CITY OF PORTLAND, MAINE

PLANNING BOARD

March 17, 2015

Project Name: Midtown
Project ID: #2014-203
Address: 59 Somerset Street
CBL: 34-B-2, 3, 4, 5, 22 and 34-D-3, 9, 10
Applicant: FEDEQ DV001, LLC.
Planner: Richard Knowland

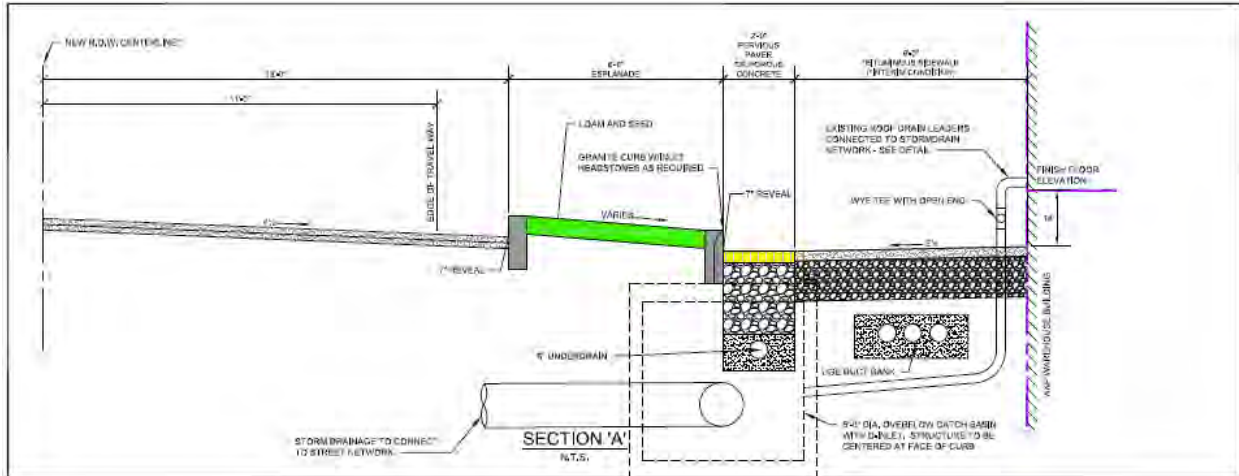
The FST design required certain waivers in street design standards (between Chestnut and Elm) to address this concern but the City was not comfortable supporting these waivers during the initial review. Although the Pearl to Chestnut street design was approved by the Board, the Chestnut to Elm section was left as a condition of approval.

Subsequently the Department of Public Services met with Planning staff and development review consultants to discuss street design waivers for the street adjacent to the Noyes building. These discussions concluded the City could support certain design exceptions (waivers) for the Somerset Street cross section between Chestnut and Elm as stated below:

- Curb reveal of 6 inch (minimum) in lieu of City Standard of 7 inches. Note: Curb reveal should be the same height along entire block and on both sides of street to aid in future pavement milling and/or overlay projects.

- Sidewalk cross slope of 0.5% minimum in certain unique locations and 2% maximum in lieu of City Standard of 2%; okay for certain areas to exceed 2% cross slope (up to 4% max) so long as there is 5 feet wide accessible route with 2 % maximum cross slope at that location.

Midtown Three Typical Floor Plans

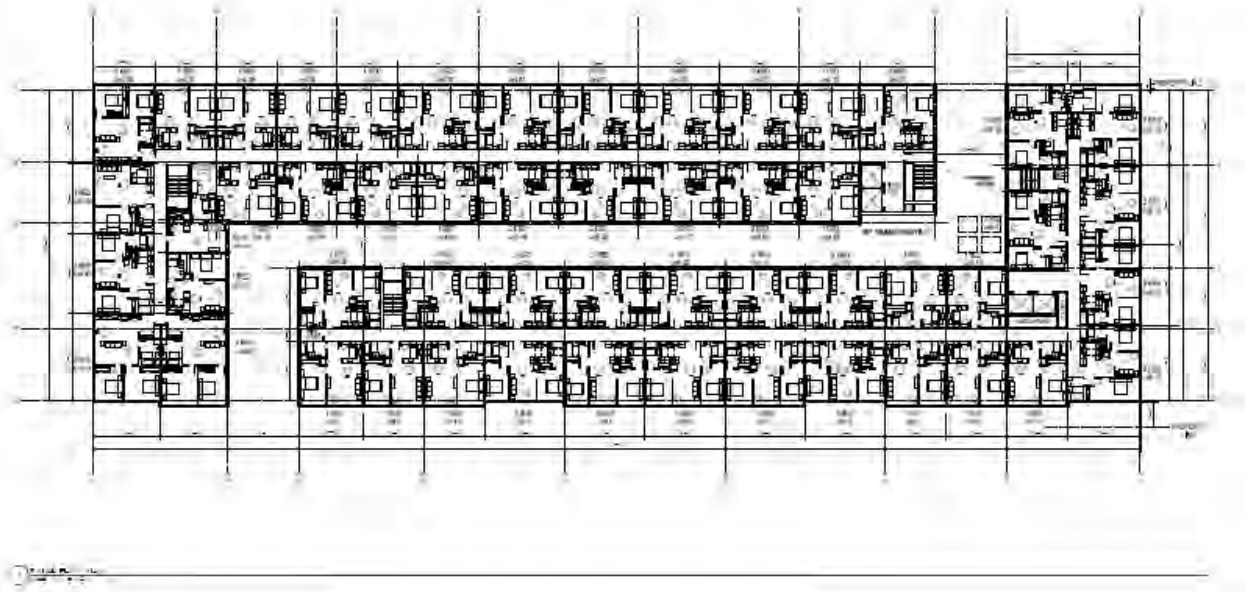
Comment: This standard mirrors to some extent the requirements of the B-7 Design Standards, specifically the Purpose Statement #4 and Standard A-1, which reference “access to light and air”. Midtown One and Four are designed with all units facing exterior views with ample sunlight and air. Midtown Three is comprised of

two long (346' x 55') 'L'-shaped buildings above the retail first floor, (see floor plan below) Subject to verification with the architects, we understand that each dwelling has a sufficient amount of windows. The Department's position is that Midtown Three meets this standard for sunlight and air.
